South Texas Project Electric Generating Station P.O. Box 289 Wadsworth, Texas 77483

South Texas Project
Units 1 and 2
Docket Nos. STN 50-498, STN 50-499
Response to Requests for Additional Information for the
South Texas Project License Renewal Application
Aging Management Program, Set 16 (TAC Nos. ME4936 and ME4937)

RAI B2.1.37-3

Figure A-1

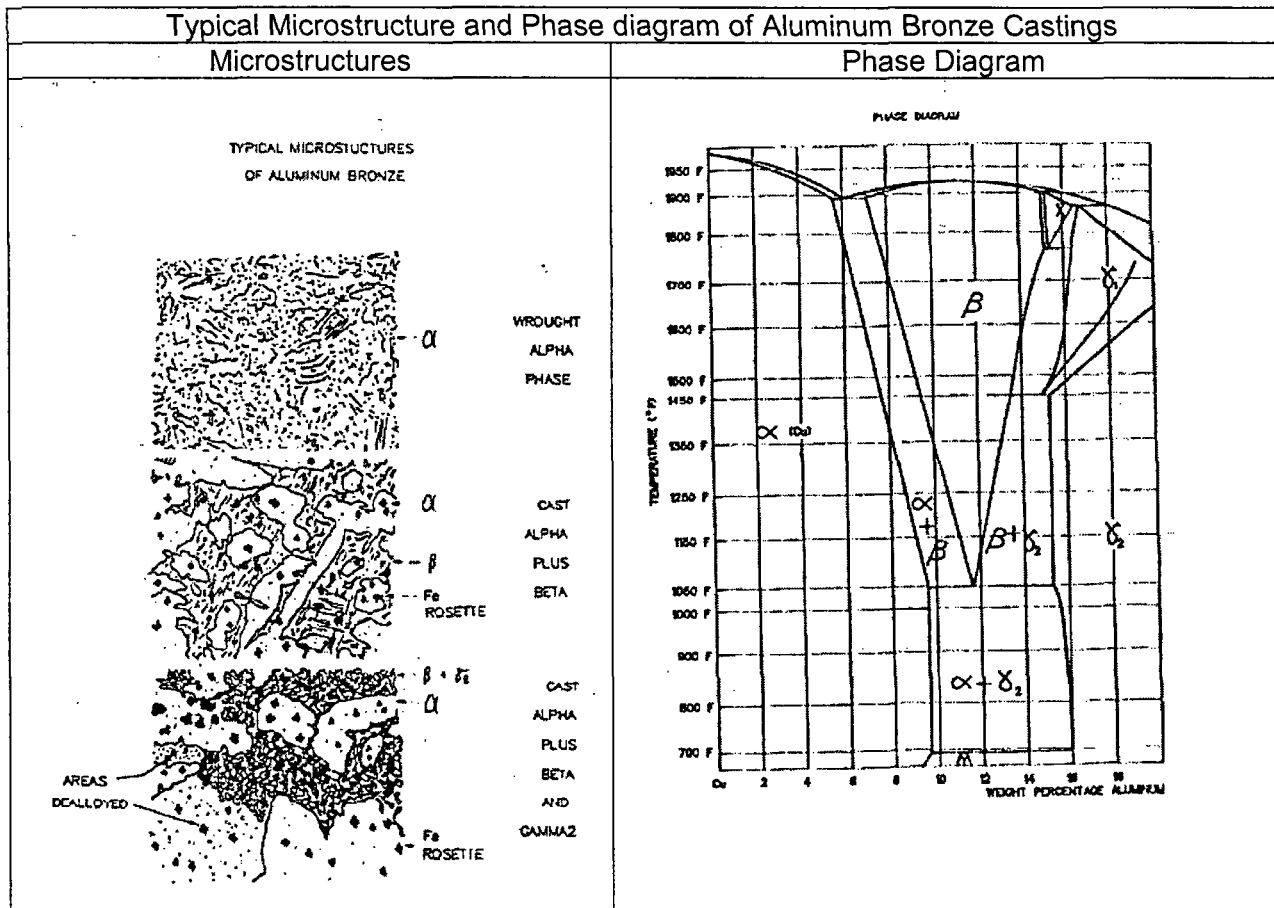
- a. State the phase composition of the material of the susceptible components (e.g., γ_2 , β , a). State which phase(s) of the material are significantly present, which phase is the continuous phase, and which phase(s) are leached. Given the composition of the dealloyed components identified to date, state the basis for why the ultimate tensile strength used in the structural analysis of the degraded components is a conservative value. Provide metallurgical analyses including micrographs and chemical analyses sufficient to demonstrate an understanding of the phase distributions, including whether

Figure A-1 provides a typical microstructure and phase diagram of aluminum bronze castings.

Figure G-1

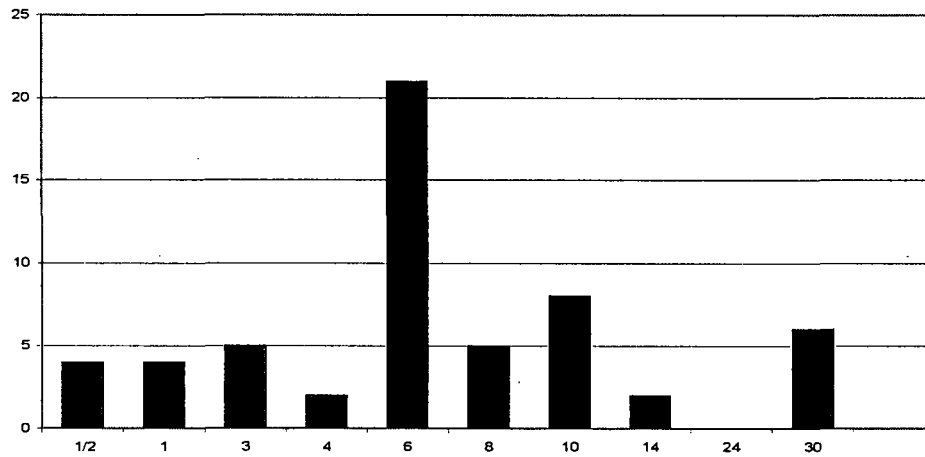
g. Revise LRA Sections A1.37 and B2.1.37, and Commitment No. 39 to reflect:

- A sample size that is sufficiently statistically-based to confirm that the extent of further dealloying or crack propagation is known.
- State the basis for why destructive sampling will only be conducted if leakage occurs, or, for both leakage and non-leakage scenarios, state the number of samples that will be destructively examined in each 10-year period starting 10 years prior to the period of extended operation.

The following figures show some of the data that STP has collected over the years regarding the ECW system failures. The important points regarding these plots are as follows:

- The overall failure rate has declined since discovery of dealloying in 1987.
- The highest numbers of failures occurred early in the life of the plant, representing the infant mortality part of a bathtub curve.
- The failure rate suggests that the most susceptible components have already failed.
- The declining trend in the number of failures is due in part to a decrease in the at-risk population of cast components after they were replaced with wrought aluminum bronze material in 1990.
